Sunland Tujunga Alliance, Inc.
P.O. Box 123
Tujunga, CA 91043
www.sunlandtujungaalliance.com

APPEAL OF ZONING ADMINISTRATOR'S DETERMINATION

Location: 6340 -6346 West Sister Elsie Drive

Case No. ZA 2012-3329 (ZV) (ZAD)

EXHIBIT A

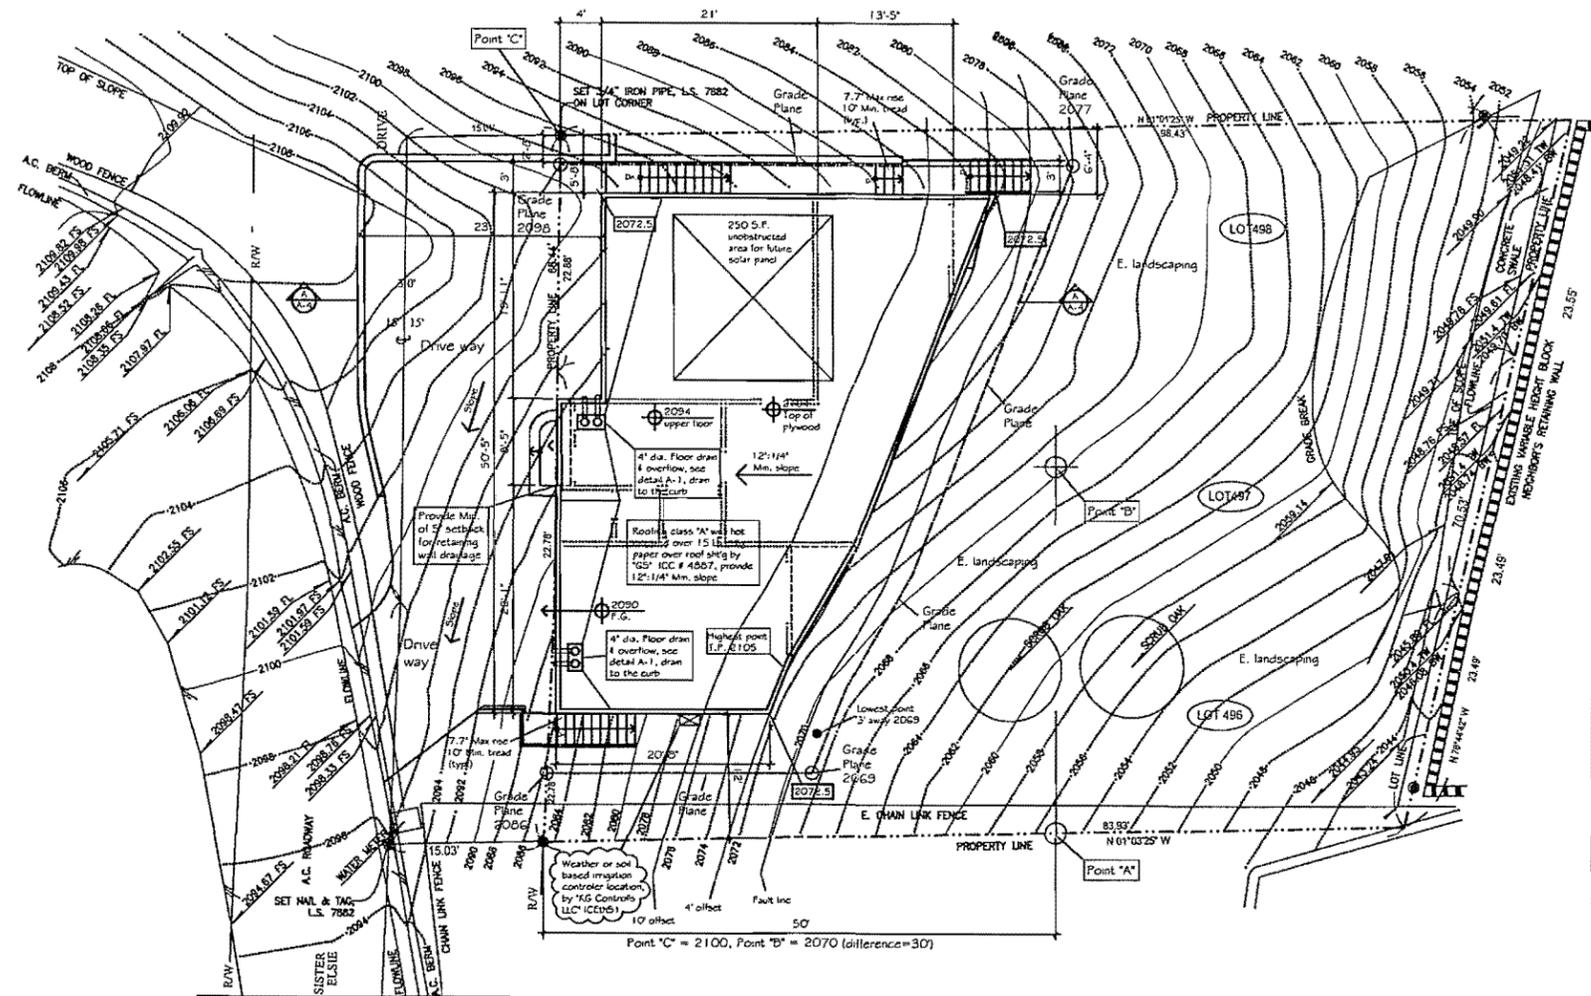
- The proposed size of the dwelling and attached garage exceed the maximum amount of floor area allowed on the property (1,147 square feet).
- The grant of the requested variances would undermine the intent of the City's Hillside Ordinance (LAMC, Section 12.21.A.17), approving a structure over twice the size allowed. The height and setback variances would not be needed if the dwelling conformed to the required FAR of the Hillside Ordinance.

The additional variances (pertaining to the front and side yard setbacks and building height) also are not a function of the unusual property shape which would make it difficult to construct an allowable 1,147 square foot dwelling. Instead, they are being requested solely to provide for construction of a house which would be more than twice the allowable size in this zone/vicinity.

The project is not architecturally compatible with its surroundings. The height, scale, and massing of the residential structure easily exceed that of most structures in the neighborhood. For example, the single-family residences located to the immediate northeast of the project site have been constructed at heights less than 36-feet. The project proposes a structural height of 36-feet (2 stories). The project is not consistent with Policy 1-3.2 of the Community Plan.
